AMENDMENT TO THE SPECIFICATION

AMENDMENT TO THE DRAWINGS

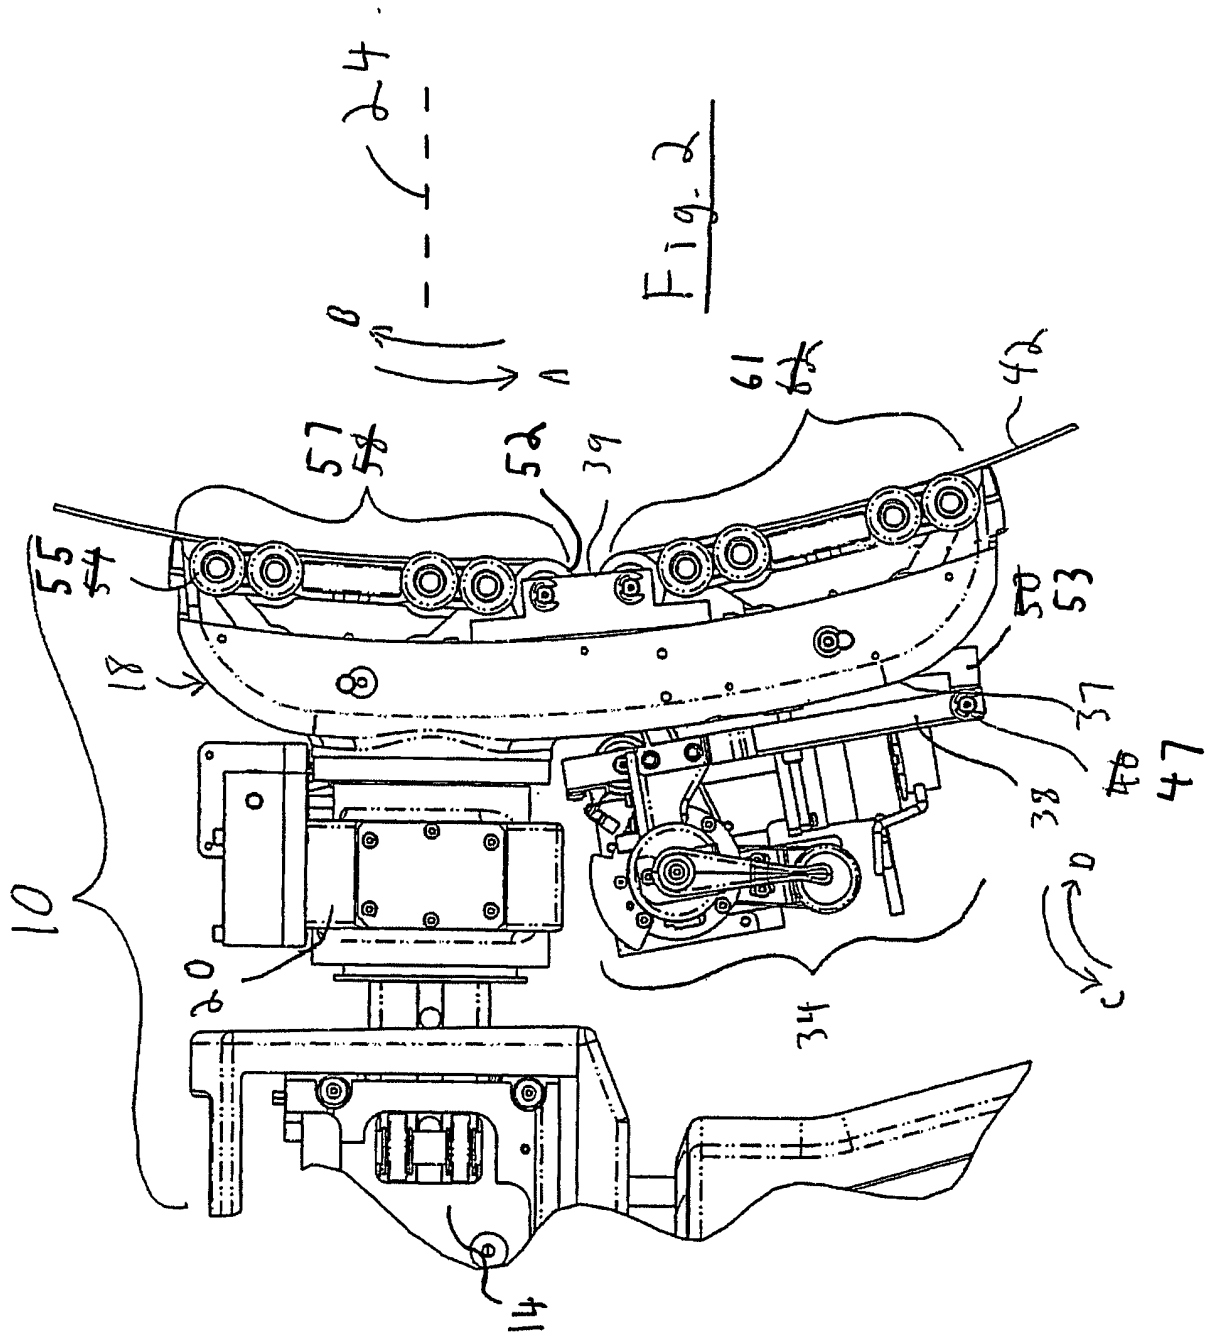
The attached sheets of drawings include changes to Figures 2 and 4. These sheets replace the original sheets including Figures 2 and 4, respectively. In Figure 2, previously omitted element 52 has been added, element 54 has been changed to 55, element 58 has been changed to 57, element 62 has been changed to 61, element 50 has been changed to 53, and element 46 has been changed to 47. In Figure 4, element 90 has been changed to 92.
